CITY PLANNING COMMISSION

APPLICATION: Planning Commission review of two office/warehouse buildings on 3.85+ vacant acres in the Heavy Commercial-Review (C-4-R) and General Commercial (C-2) Zones

LOCATION: NE corner Northgate Boulevard and Patio Drive

C. NO. P84-260

ZONING MAP

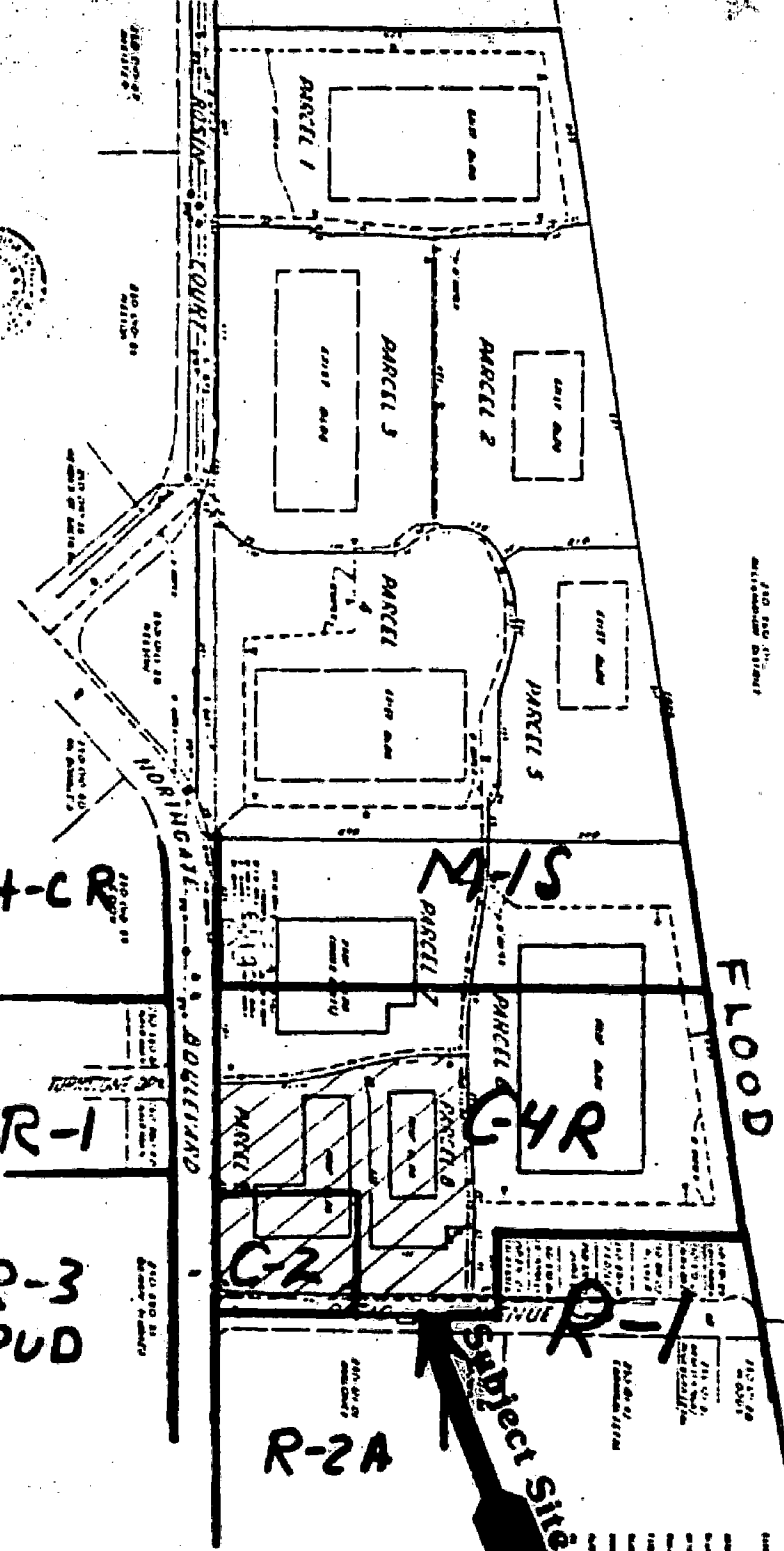
7. It should be noted that a portion of Building H is located in the General Commercial (C-2) zone which does not allow warehouse uses. The applicant/developer should rezone this C-2 portion to bring it into conformance with the rest of the parcel and its proposed use.

8. The General Commercial (C-2) portion of this site shall be rezoned to bring it into conformance with the rest of this project and its proposed uses. This must be approved by the City Council prior to any occupancy of Building H.
